# Air New Zealand

## AKL Domestic Terminal – Affordable Pathways Final Report

Arup has undertaken a review of the Integrated Domestic Terminal (IDT) proposal and rapid development of alternative Domestic Terminal pathways over an 8 week period.

# 9. DTB plus Pier A1 – Revised Alignment (ii)

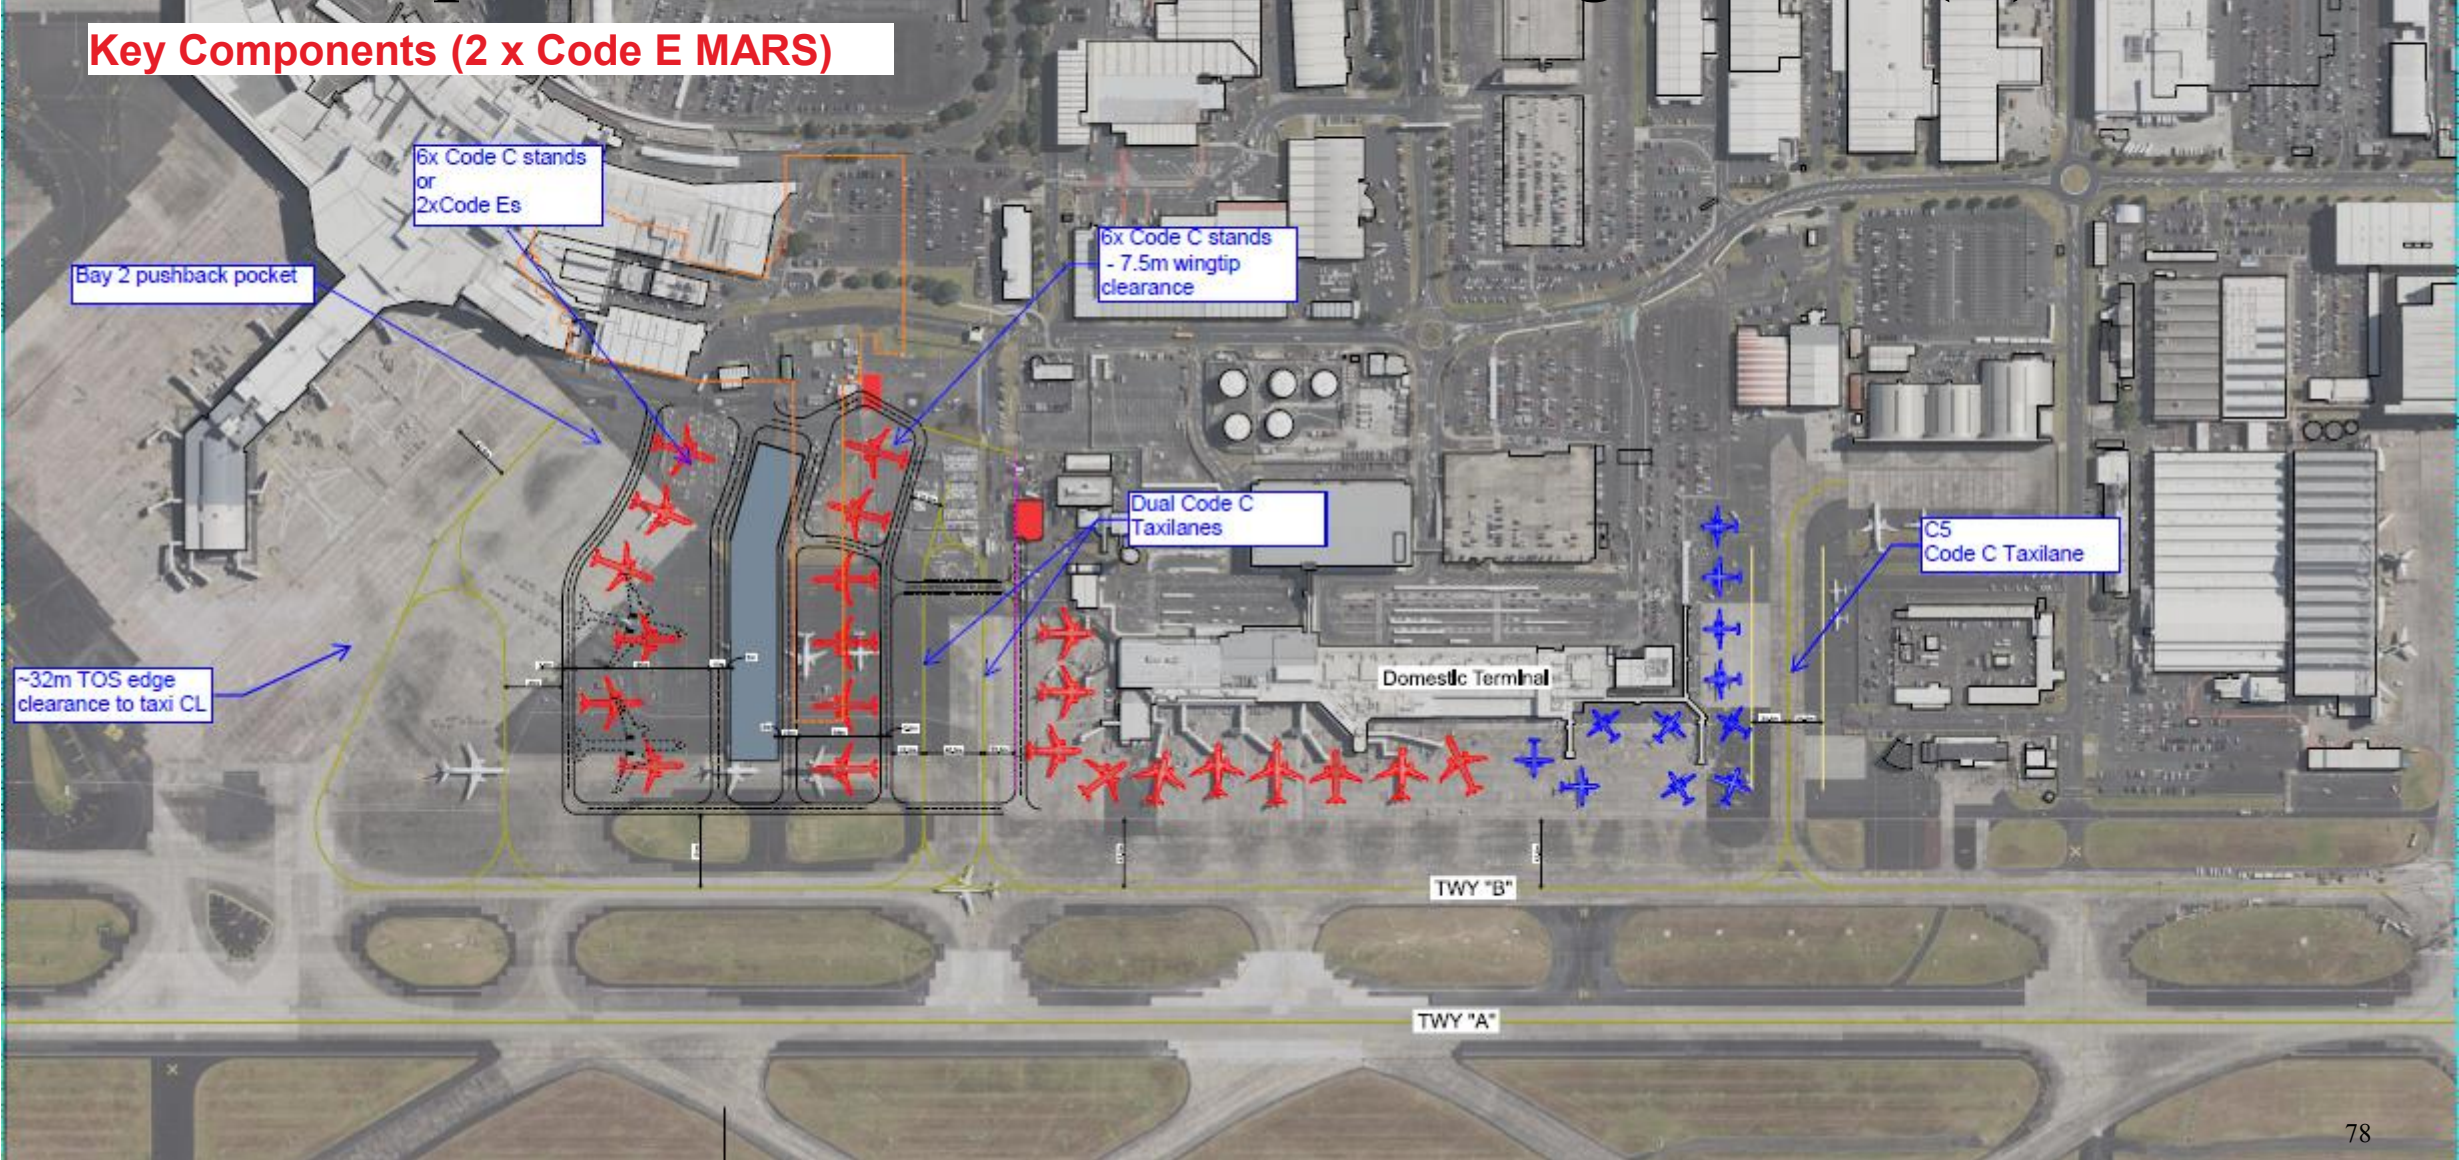
Only 2 Code E MARS stands can be provided assuming the revised A1 alignment.

- The revised alignment of Pier A1 can provide 12 Code C jet stands, or alternatively 8 Code C Jet stands and 2 Code E stands in a MARS arrangement.
- An option with DTB + A1 + A3 + Regional Headhouse can provide up to 20 Code C Jet stands and 16 turboprop stands but the Regional headhouse impacts on the “KFC” and adjacent hangar facilities.
